V2500-A1/A5/D5 PROPULSION SYSTEMS SERVICE BULLETIN

This document transmits the Initial Issue of Service Bulletin V2500-ENG-72-0622.

ENGINE – SEAL ASSEMBLY, NO. 3 BEARING – REPLACE OR MODIFY TO IMPROVE DURABILITY**1. Planning Information****A. Effectivity****(1) Airbus A319**

Location of the No. 3 Bearing Seal Assembly 72-32-25
Figure 1

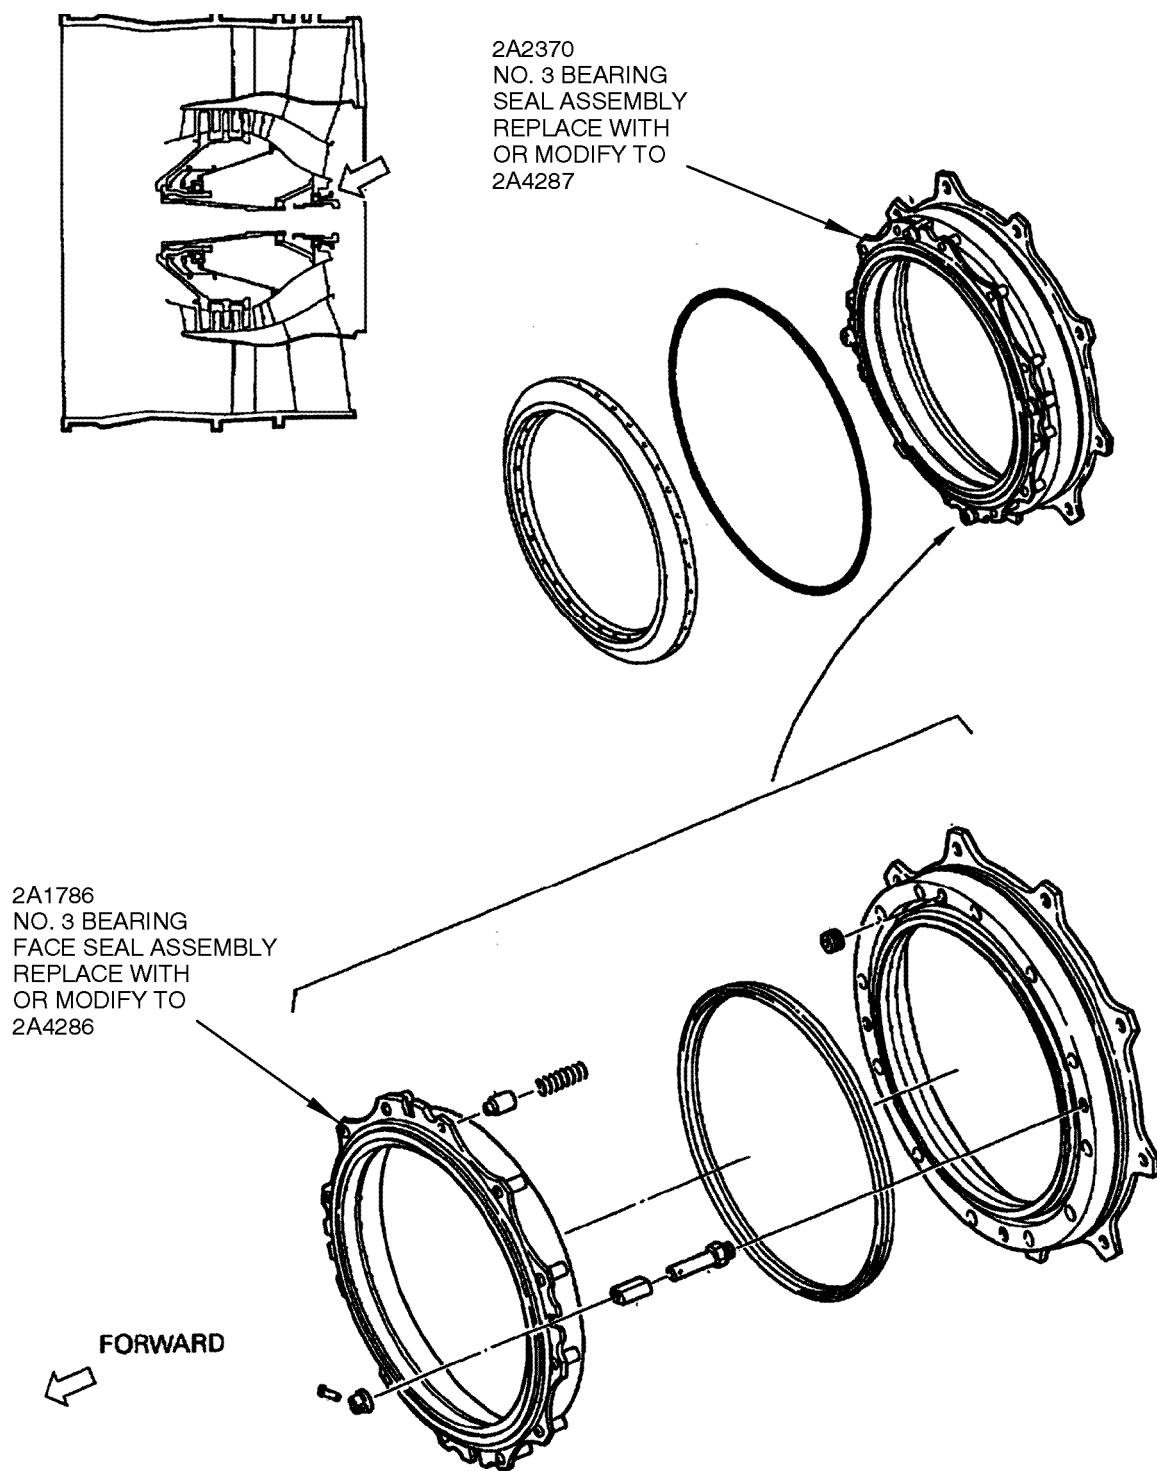
- (1) Replace No. 3 Bearing Seal Assembly, PN 2A2370 with PN 2A4287, refer to Figure 1 for the location of the assembly.

- (i) Replace No. 3 Bearing Face Seal Assembly, PN 2A1786 with PN 2A4286. See Figure 1 for the location of the assembly.
- (ii) Assemble the No. 3 bearing seal assembly by the procedure in Reference 7 or 8, Engine Manual, Task 72-32-25-440-001.
- (iii) Identify the modified No. 3 bearing seal assembly as specified in the list that follows. Use the procedure in Reference 9 or 10, Standard Practices Manual, Task 70-09-00-400-501. Use the vibration peen method. Mark the new part number near the old part number.

- (i) Send your No. 3 Bearing Face Seal Assembly, PN 2A1786 to an approved source, listed in the Vendor Services Table, for modification.
- (ii) Specify that the No. 3 bearing face seal assembly is being sent for modification per Service Bulletin No. 72-0622.

Family Tree – No. 3 Bearing Seal Assembly Ref. Catalog Sequence 72-32-25 Figure.
02 Item 100 and No. 3 Bearing Face Seal Assembly Ref. Catalog Sequence 72-32-25
Figure 02 Item 150 CHART A

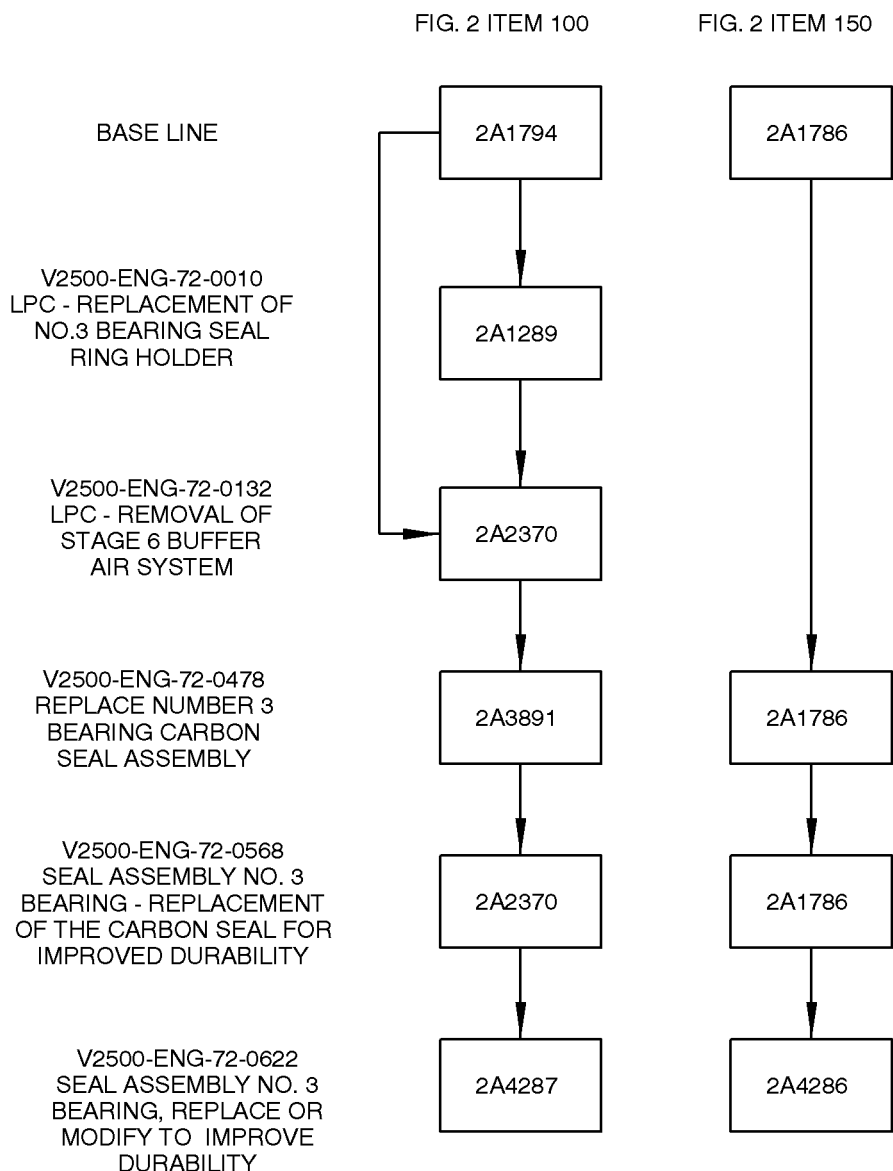
PART NUMBER CHANGE
